**Martinez Creek: Perez St to W. Huisache Ave**  
**Solicitation Number: CO-00200**  
**Job No.: 15-4802**

**ADDENDUM 4**  
**October 10, 2018**

**MARTINEZ CREEK, PEREZ ST. TO W. HUISACHE AVE. WASTEWATER MAIN REPLACEMENT  
PROJECT - RFCSP  
CO-00200**

**SANITARY SEWER BORING DETAIL**  
N.T.S.

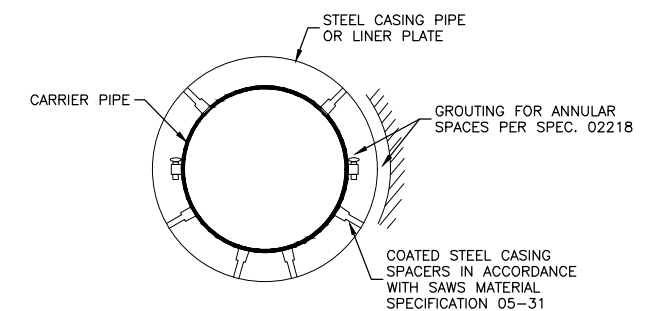
Sheet D-2: Remove and replace Plan Sheet D-2 with the revised Plan Sheet D-2 attached to this Addendum. Sheet D-2 was revised to change the sanitary sewer boring detail to show that 72-inch and 66-inch steel casing pipe shall have a minimum wall thickness of 0.75 inches and that only PVC pipe bell & spigot joints will require full joint restraint assemblies.

*Response: Refer to Modifications to Specifications and Modifications to Plans for Construction for this Addendum. 72-inch and 66-inch steel casing pipe shall have a minimum wall thickness of 0.75 inches. Specification Section 856 and Plan Sheet D-2 have been revised accordingly and included in this Addendum.*

- b. Steel; Steel casing pipe shall be ASTM A36 or A53, 0.75-inch wall thickness (66-inch and 72-inch casings). Casing pipe welds shall be continuous E-70 fillet welds. Interior welds shall be ground smooth to facilitate subsequent insertion of FRP carrier pipe on runners.
